ADDENDUM NO. 1

April 14, 2022

YOST ELEMENTARY SCHOOL ADDITIONS AND RENOVATIONS Chesterton, IN 46304

Addendum One (AD.01) to the drawings and specifications prepared by Gibraltar Design for **New Yost Elementary School** for Duneland School Corporation, Chesterton, Indiana.

A-419

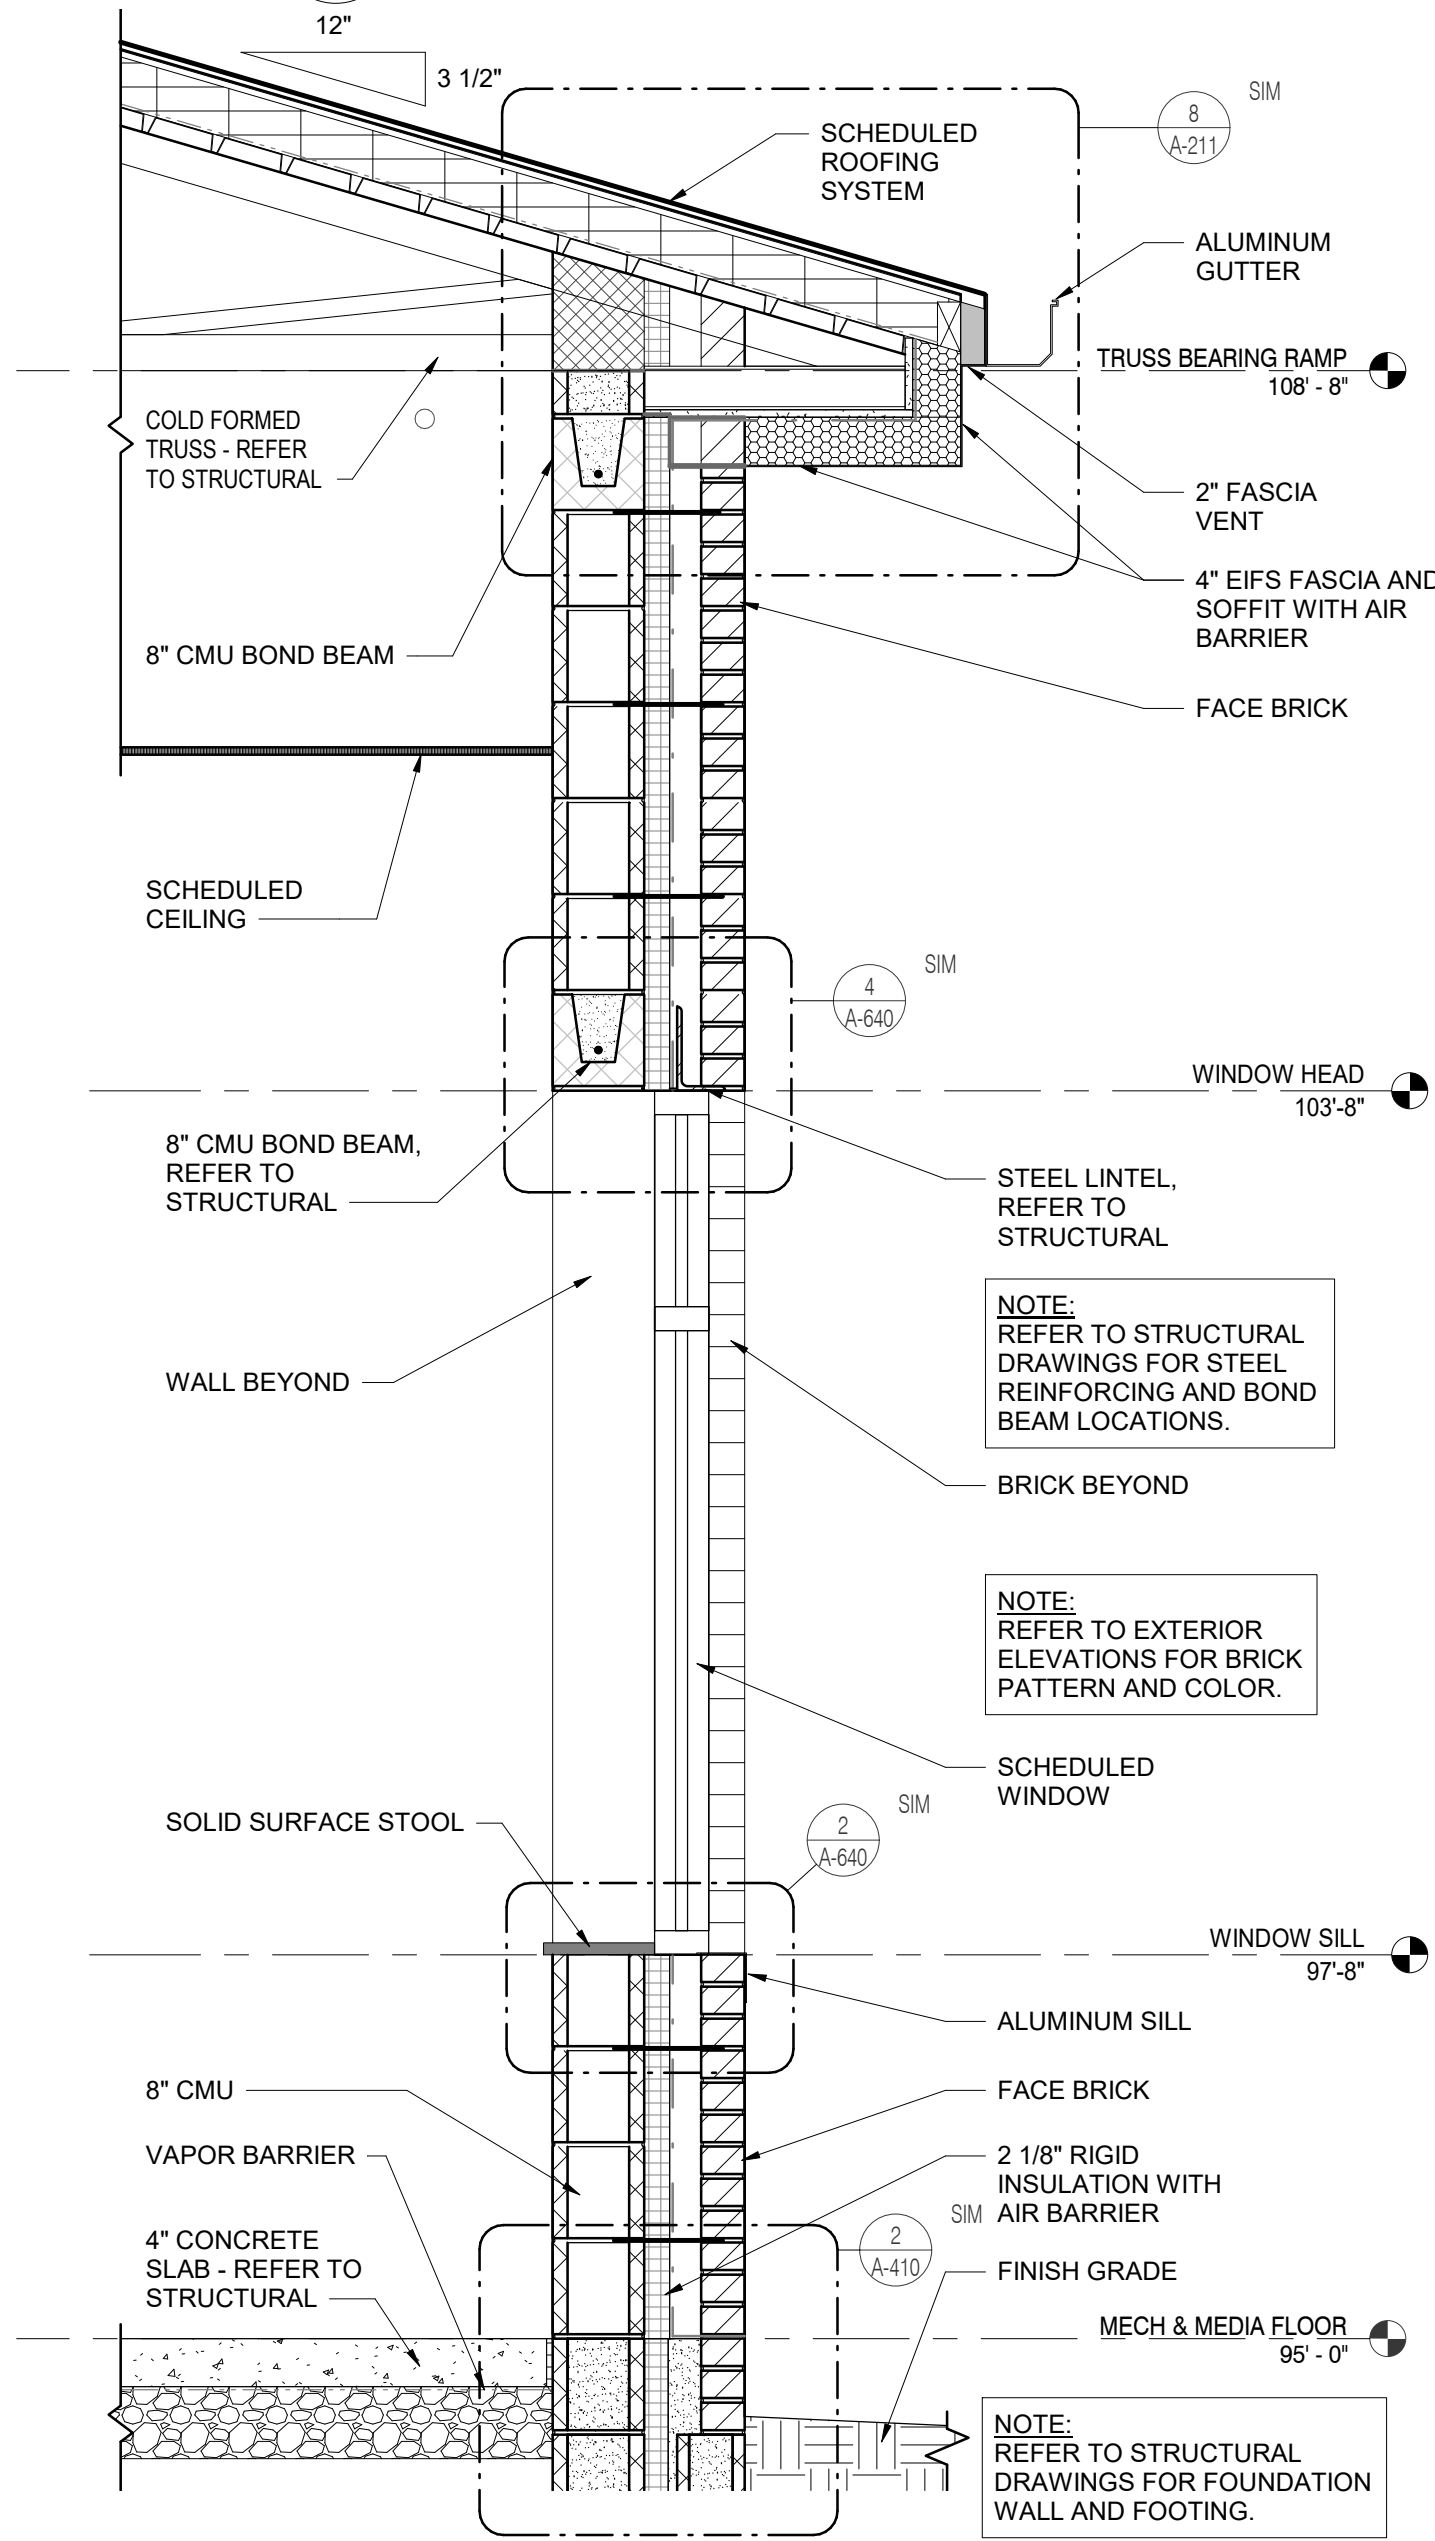
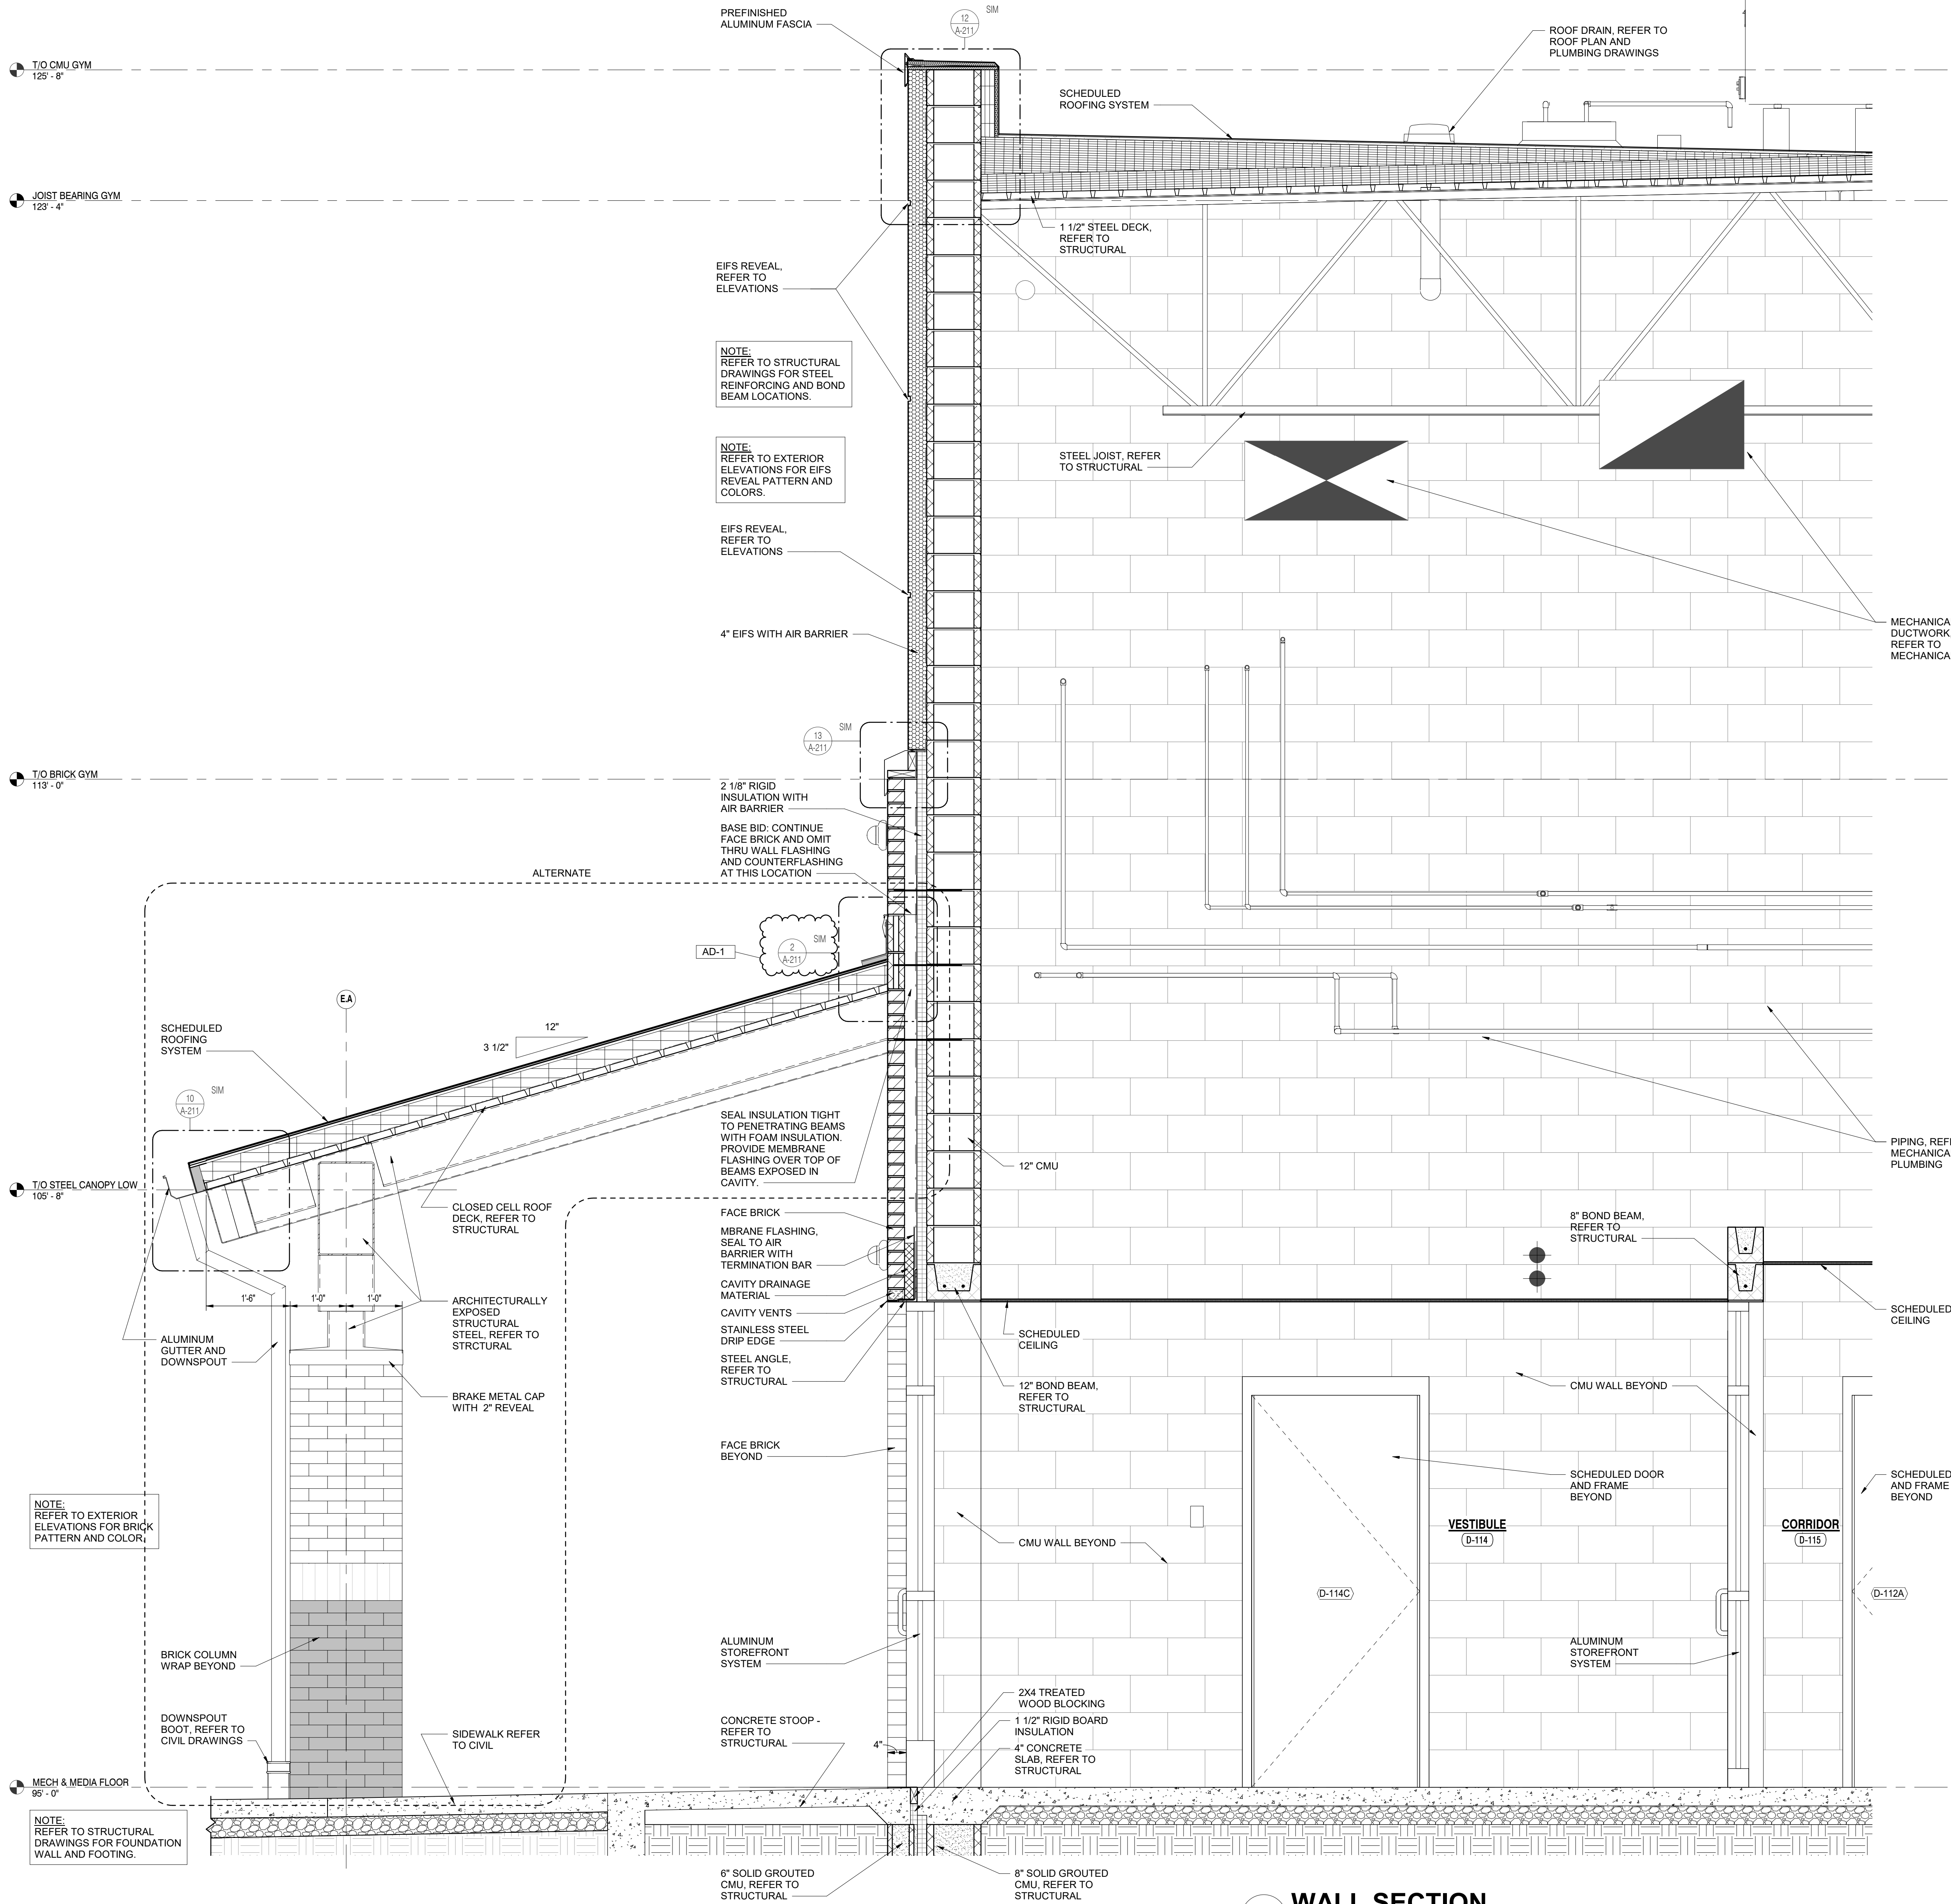
18. Sheet A-419

- A. Refer to revised full size drawing, included in this Addendum, for the following revisions:
 - 1. Change enlargement reference at top of canopy from 13/A-211 to 2/A-211.

7 CIRC. DESK FRONT SOUTH ELEVATION
A-760 3/8" = 1'-0"

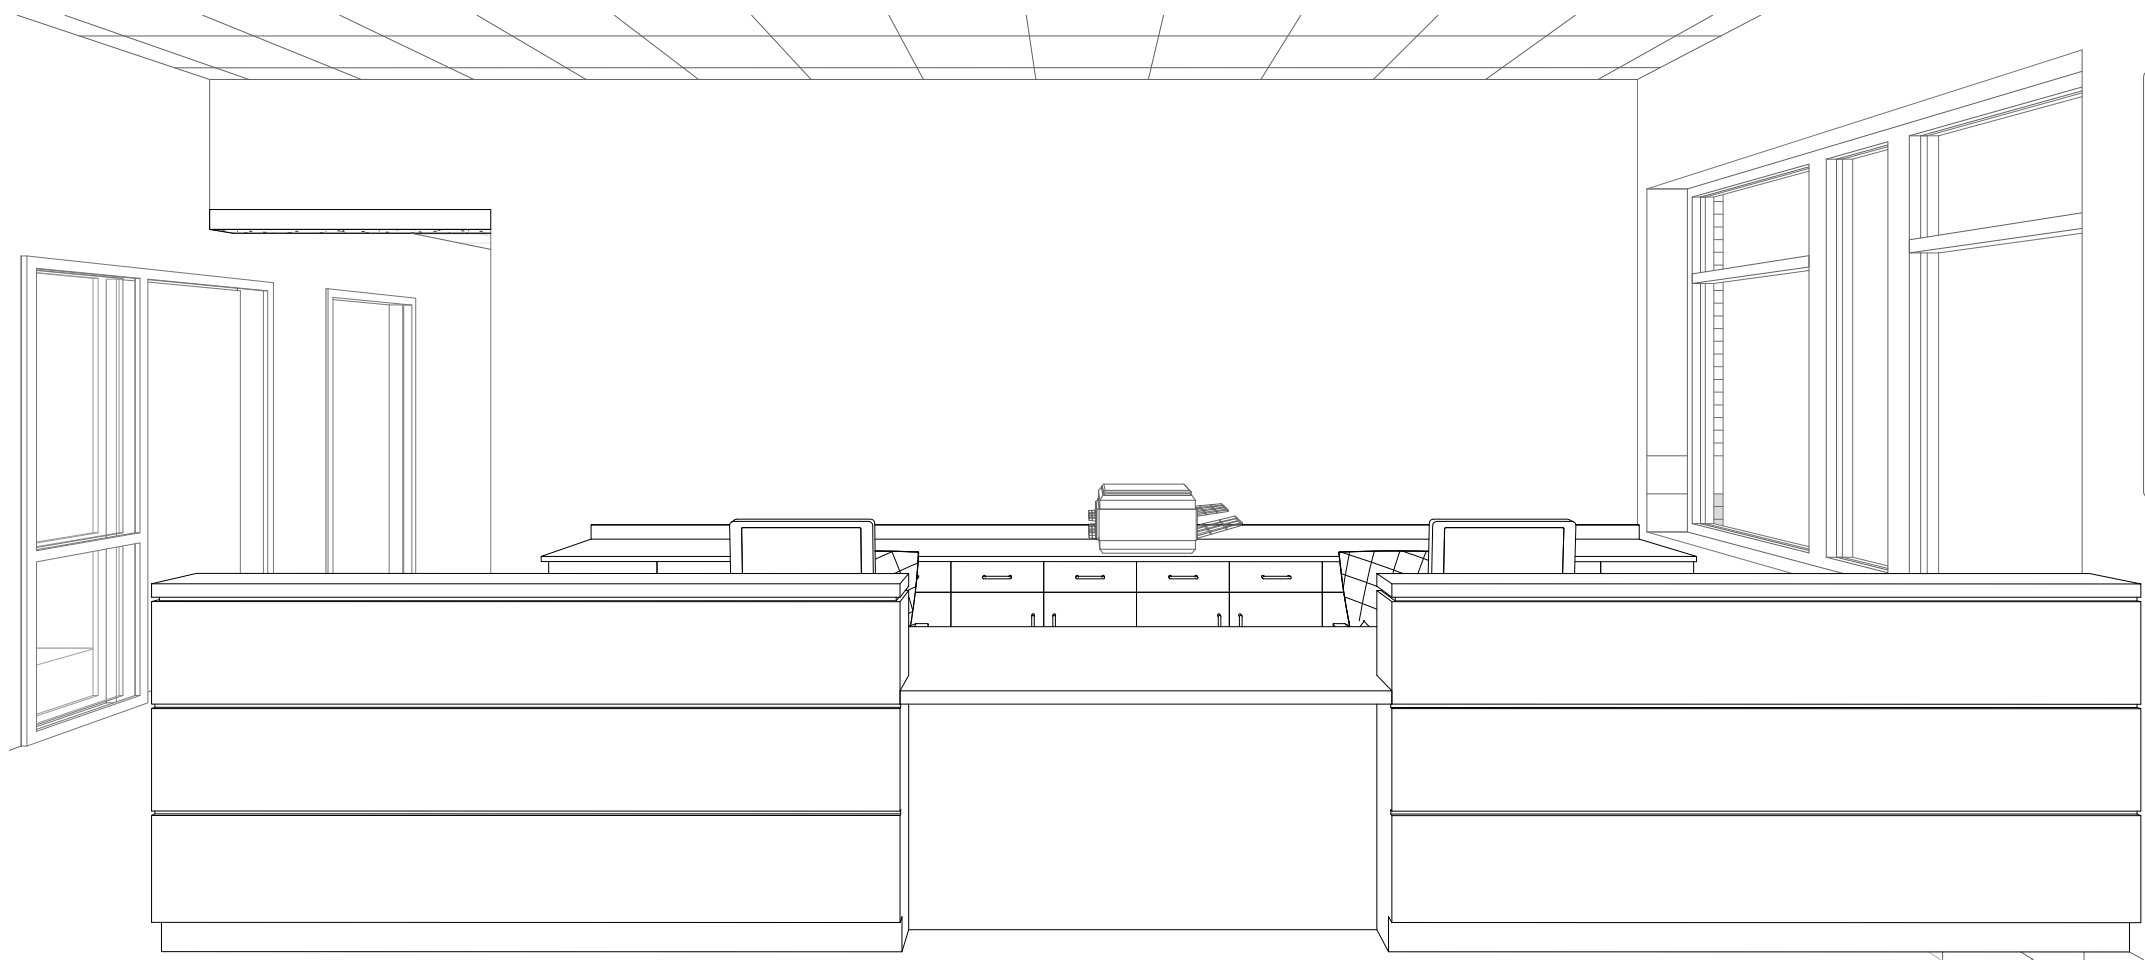
25. Sheet A-760

- A. Refer to revised full size drawing, included in this Addendum, for changed dimension Detail #7 and #11.
